Rosamond High Early College Campus Cafeteria Building
SOUTHERN KERN UNIFIED SCHOOL DISTRICT
F&M Project No. 2990
Bid Clarification No.3; Page 1 of 2

BID CLARIFICATION NO. 4

July 18, 2023

DETAILS

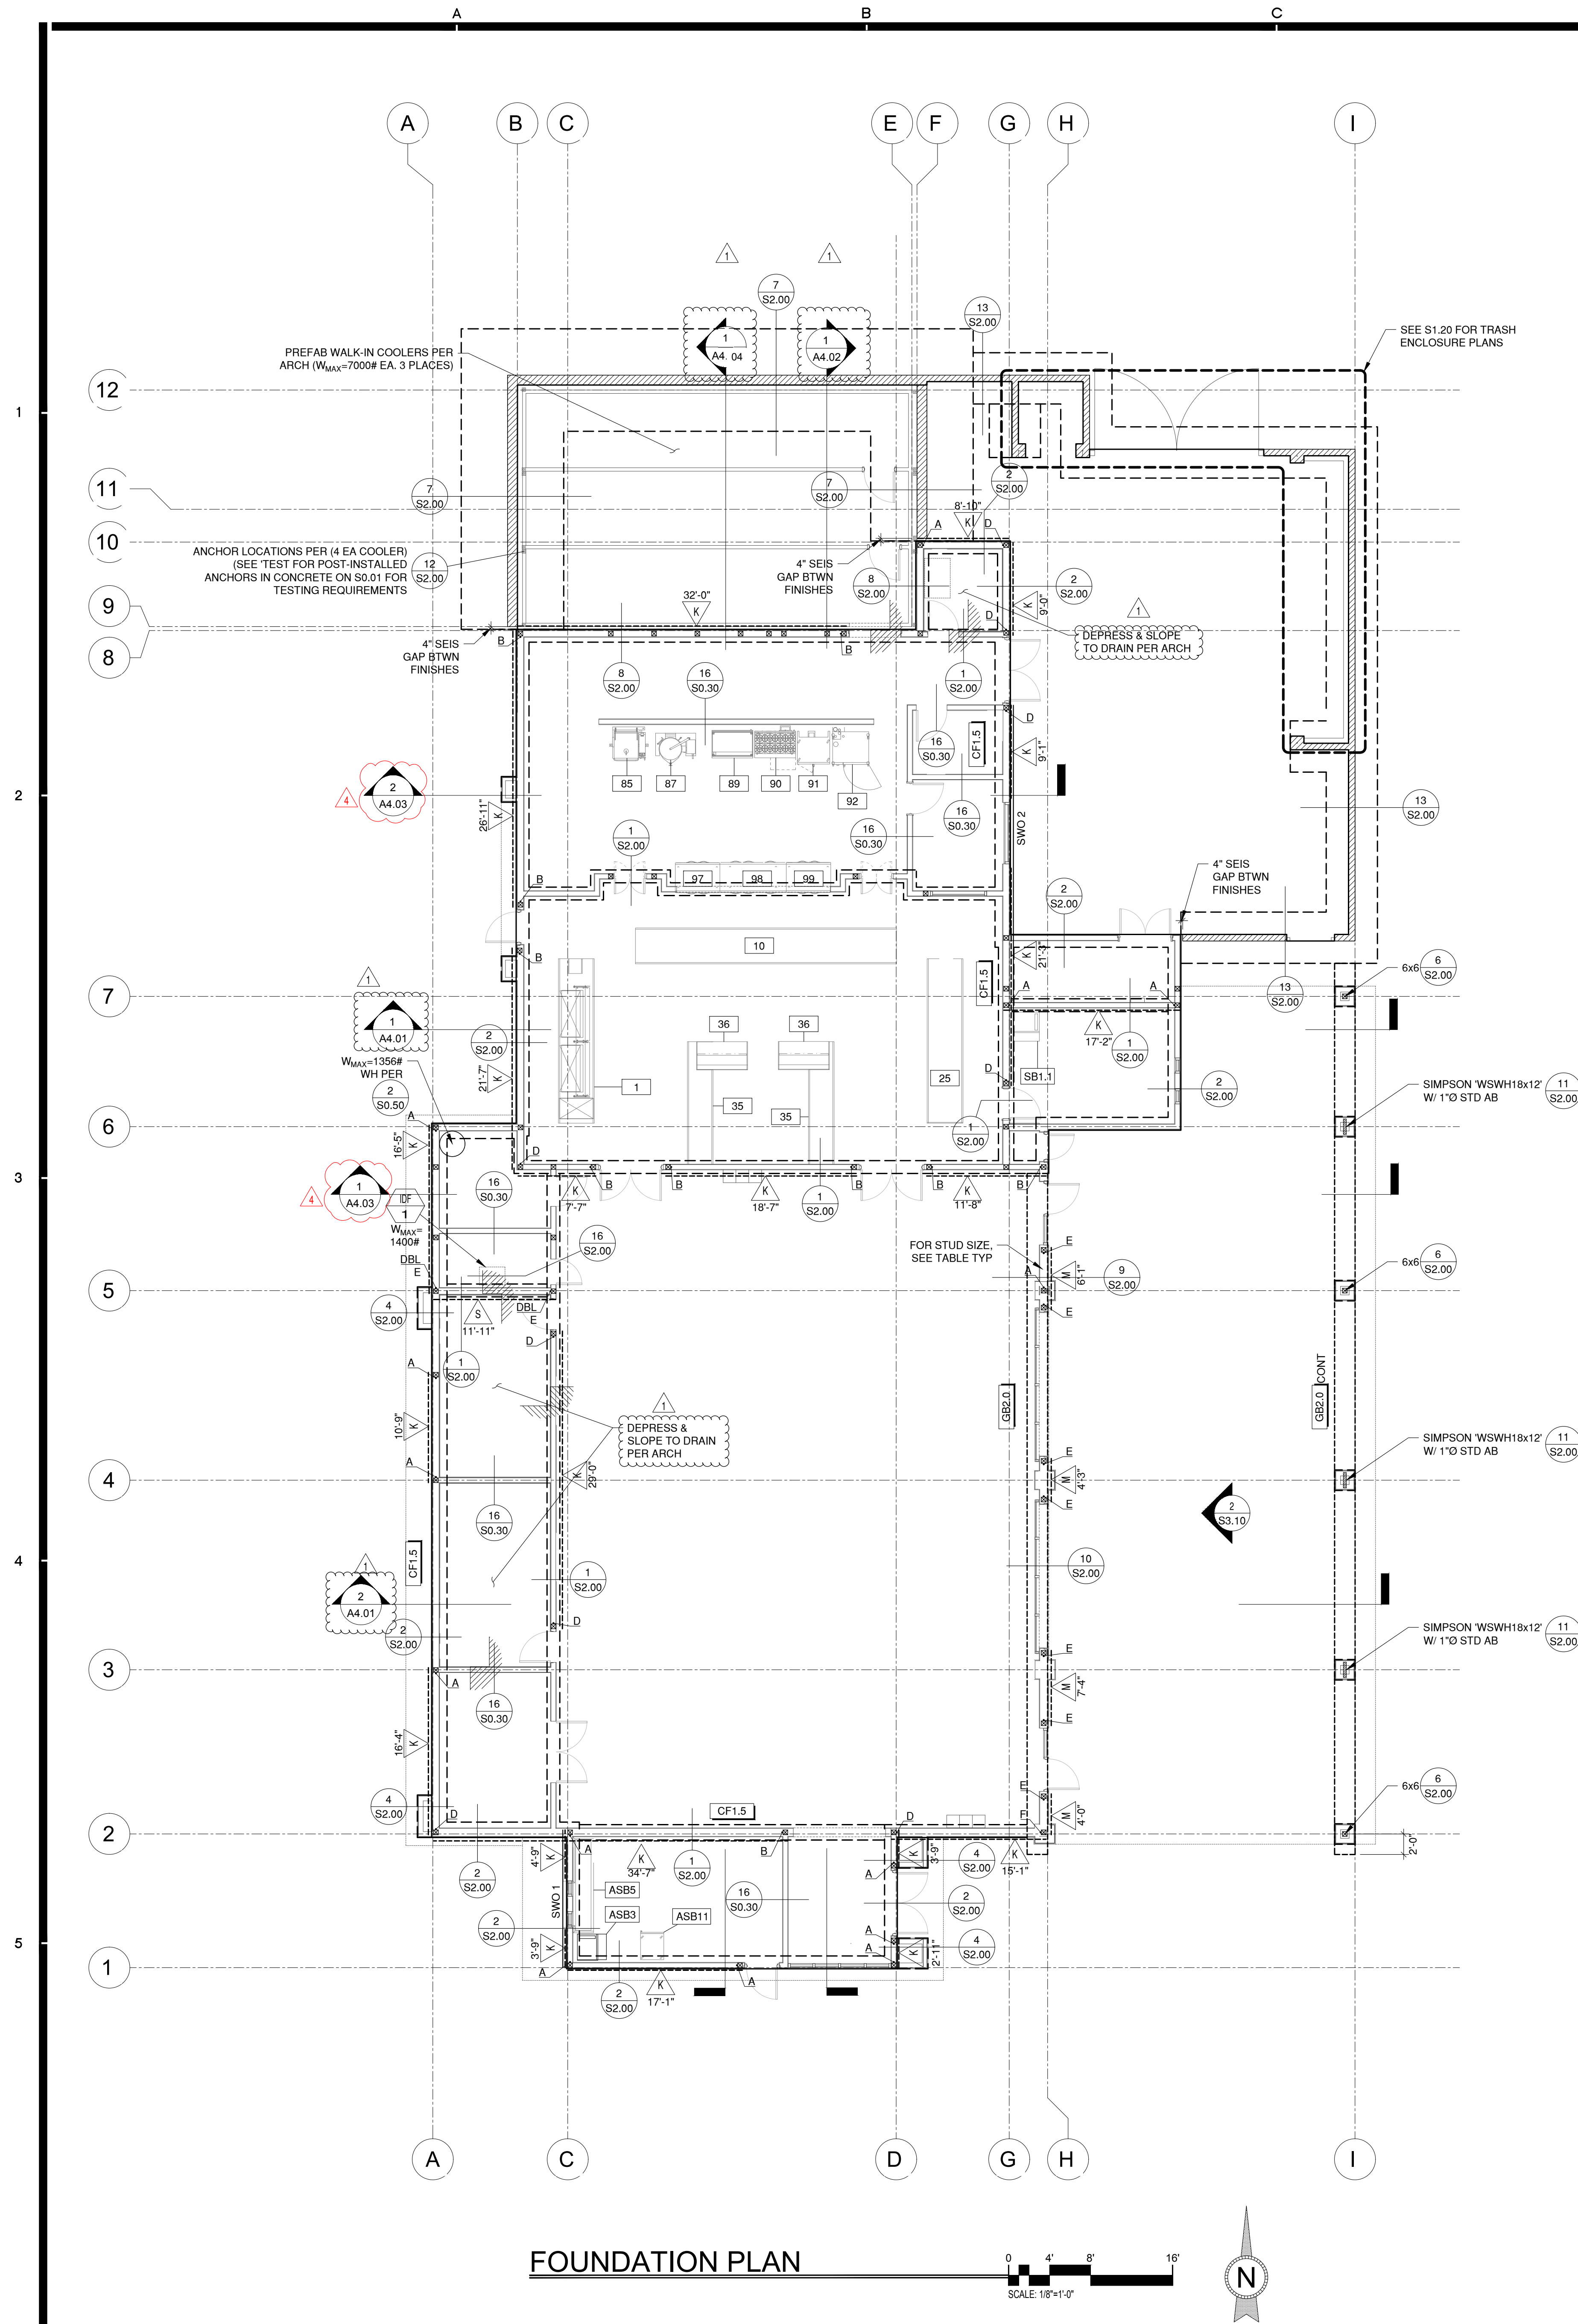
12. A7.01 – Schedules, “Bid Clarification No. 4”, with revision clouds as attached hereto.
13. A9.04 – Details, “Bid Clarification No. 4”, with revision clouds as attached hereto.

FOUNDATION
PLAN

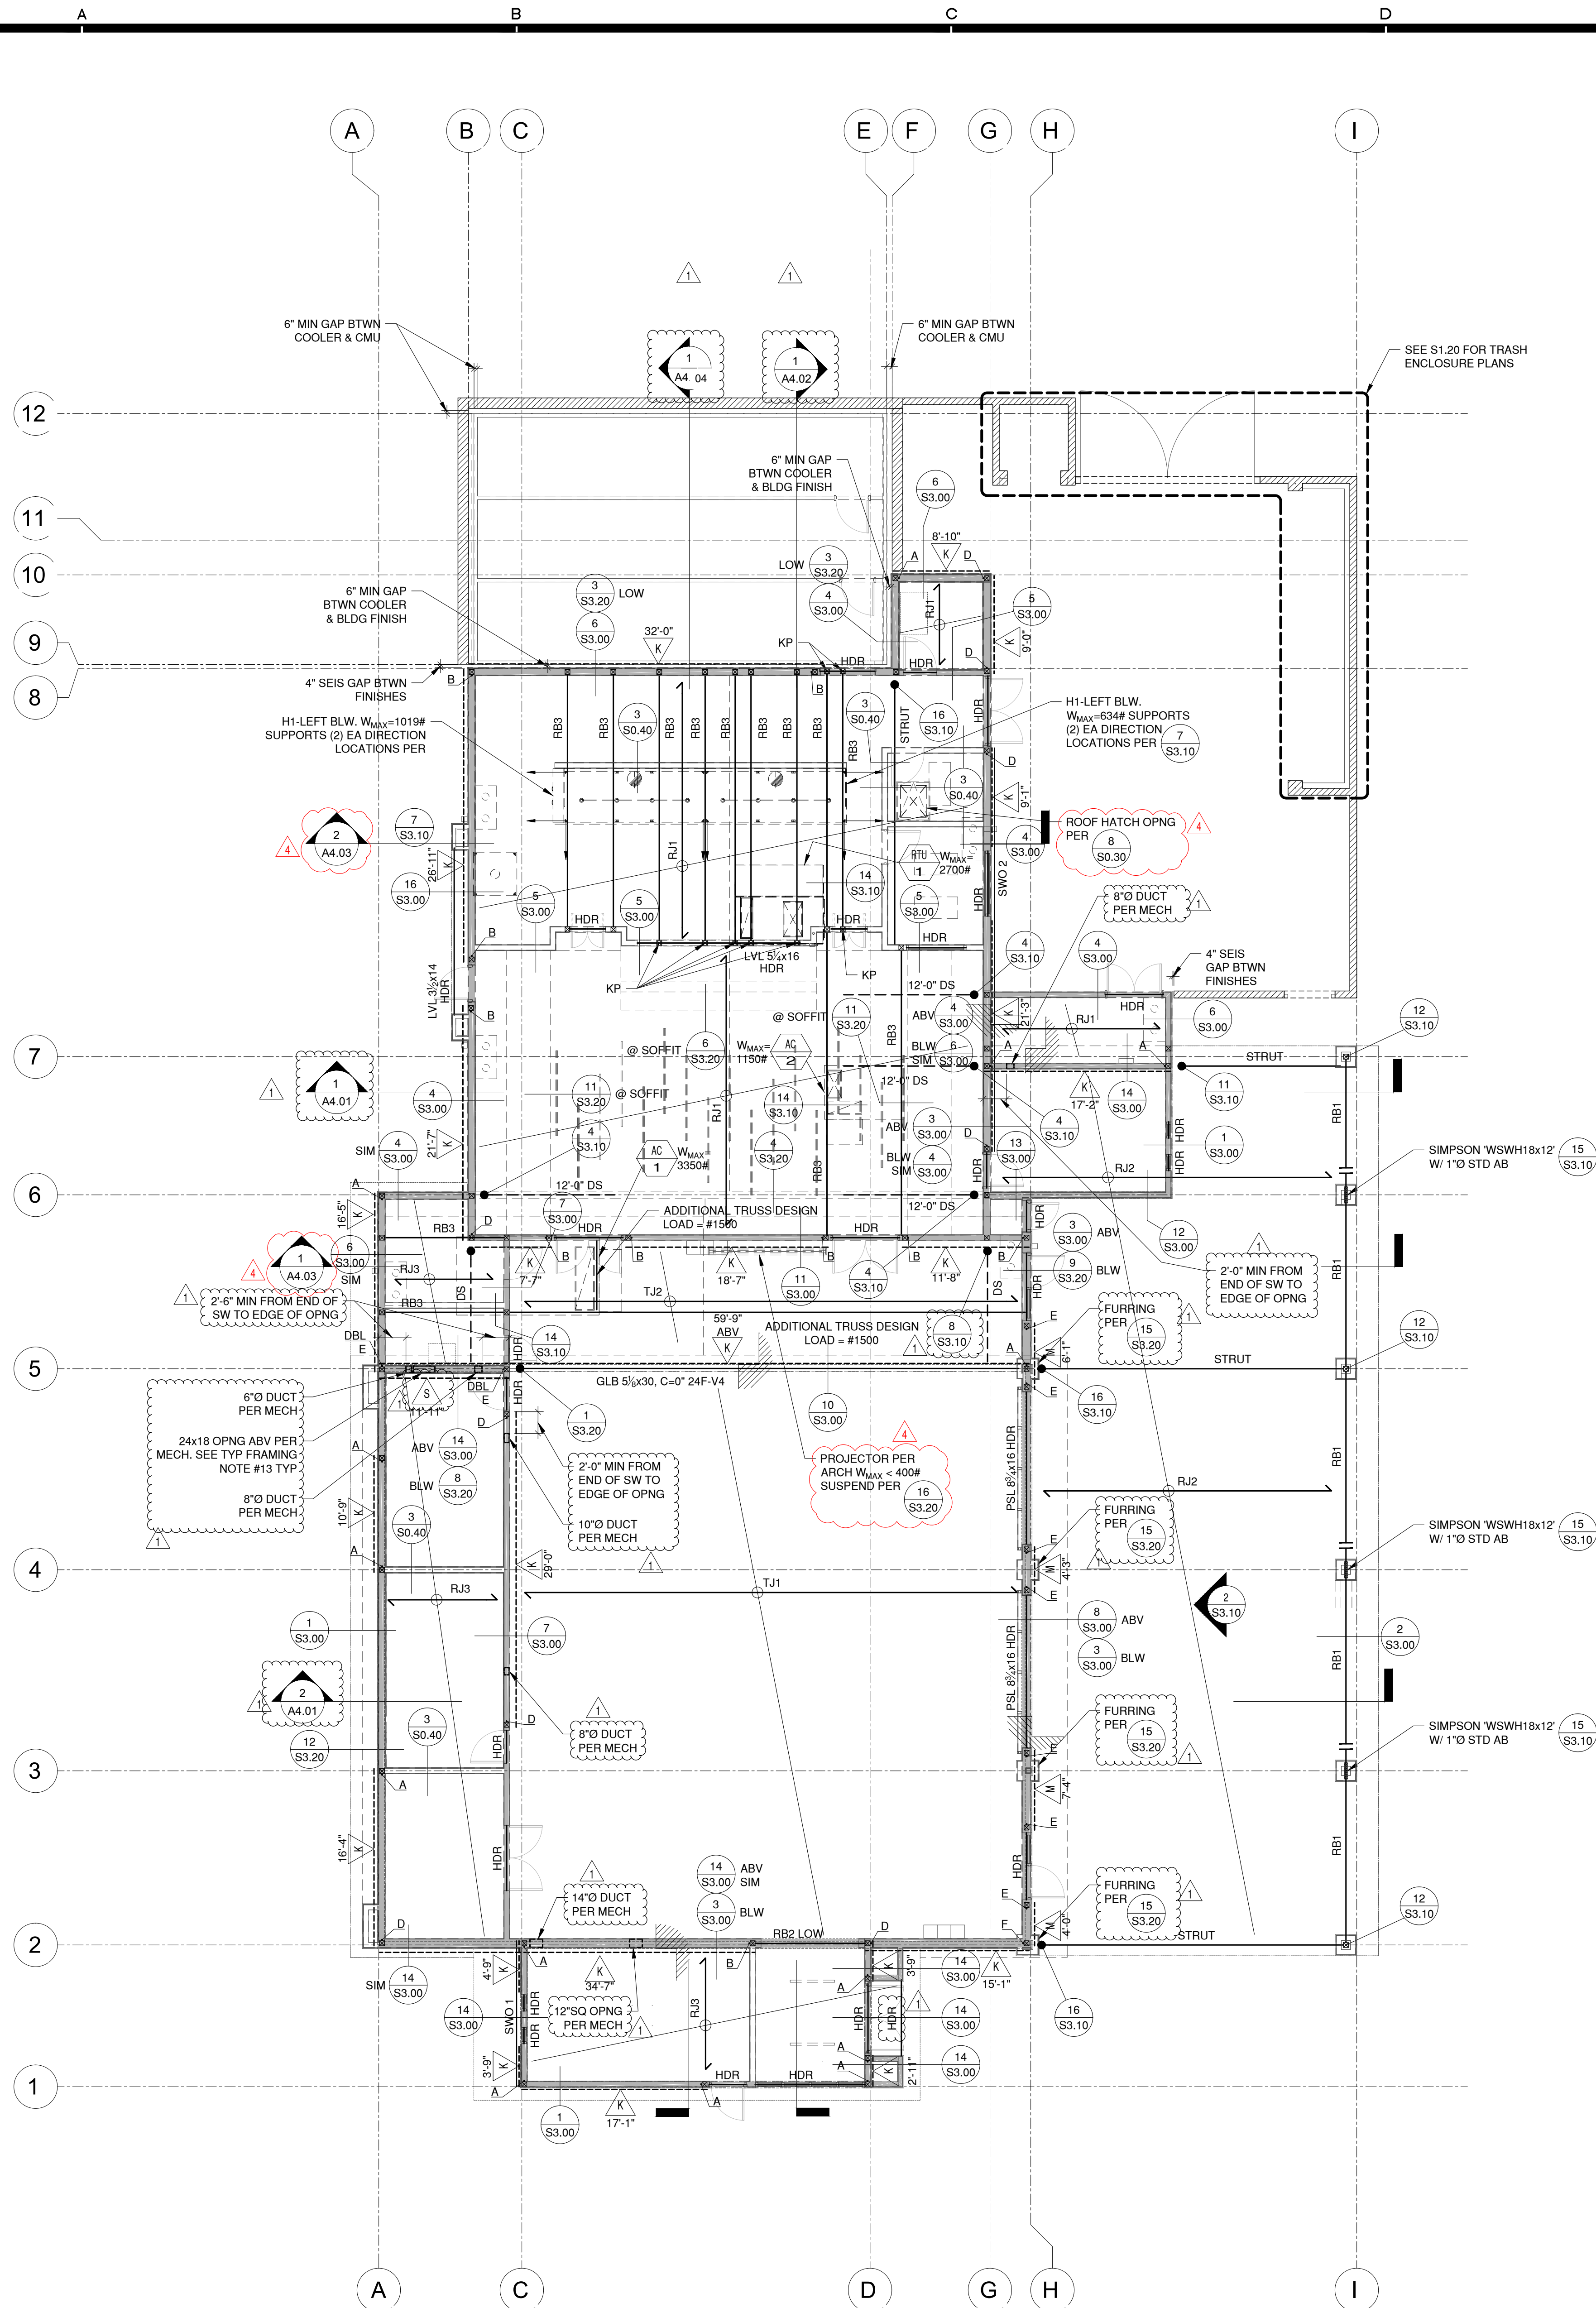
14. S1.00 – Foundation Plan, “Bid Clarification No.4”, with revision clouds as attached hereto.
15. S1.10 – Roof Framing Plan, “Bid Clarification No.4”, with revision clouds as attached hereto.

ELECTRICAL SITE PLAN

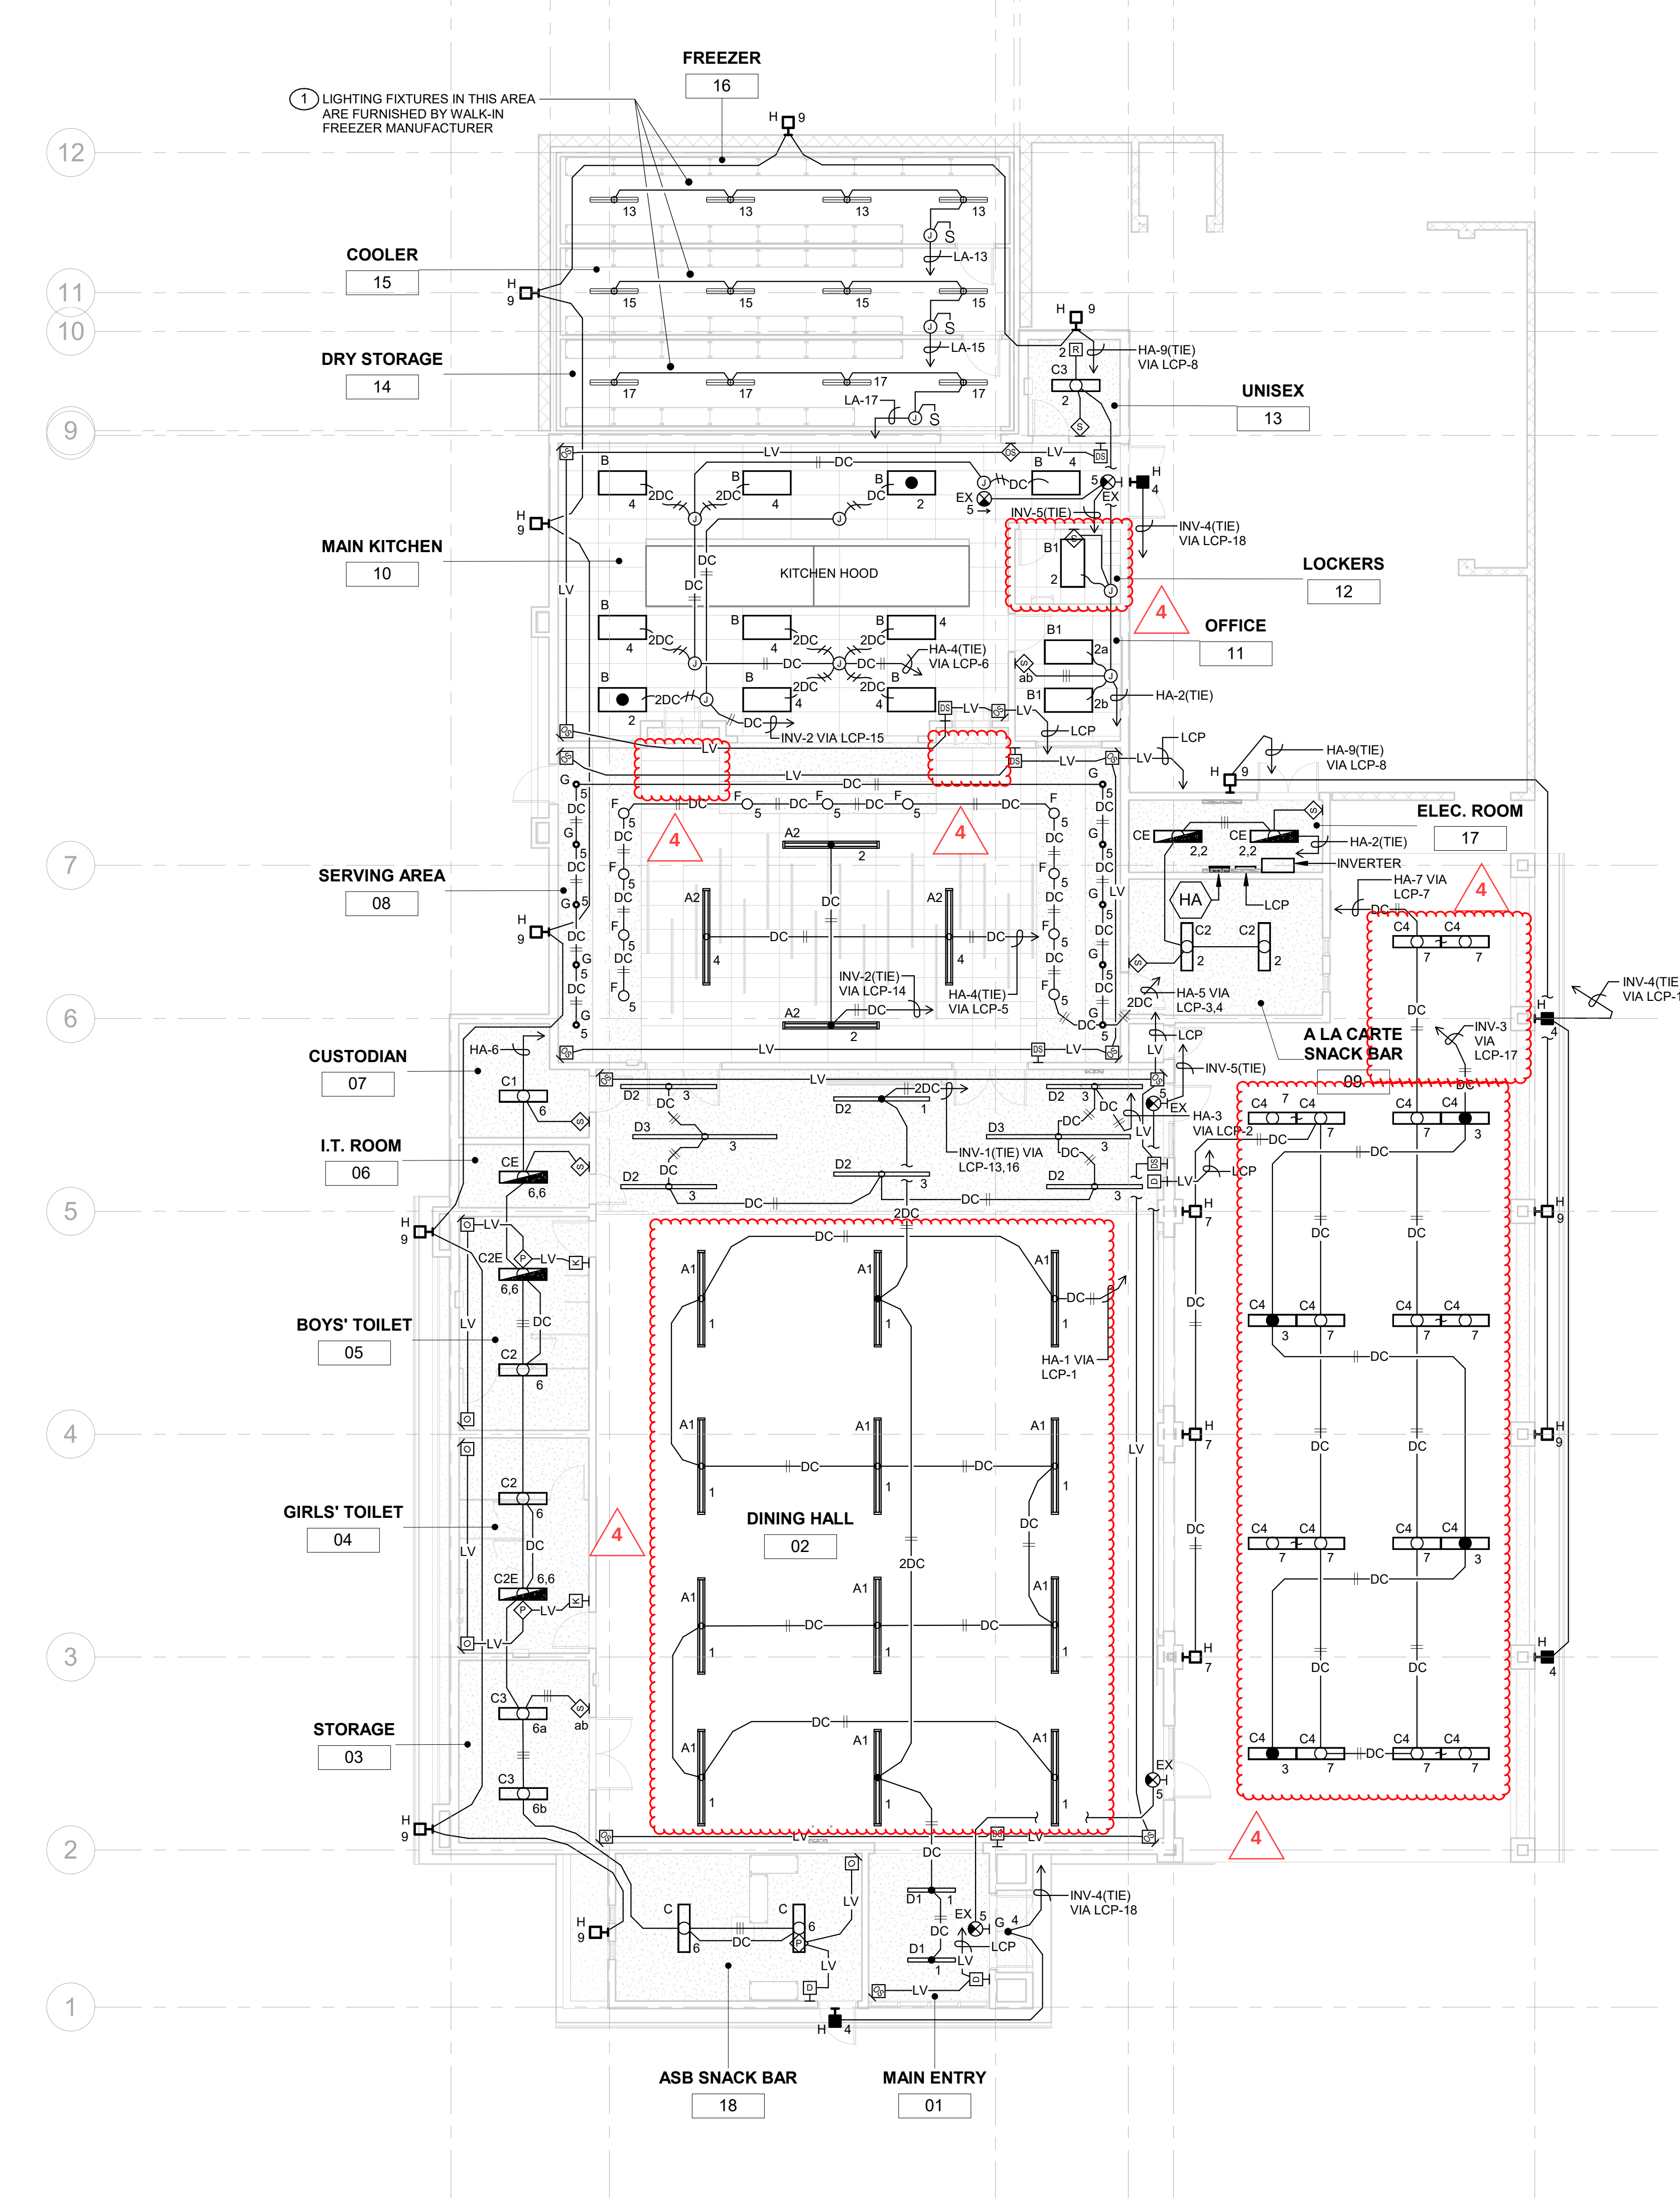
18. E201 – Electrical Site Plan – “Bid Clarification No.4”, with revision clouds as attached hereto.
19. E401 – Lighting Plan – “Bid Clarification No.4”, with revision clouds as attached hereto.
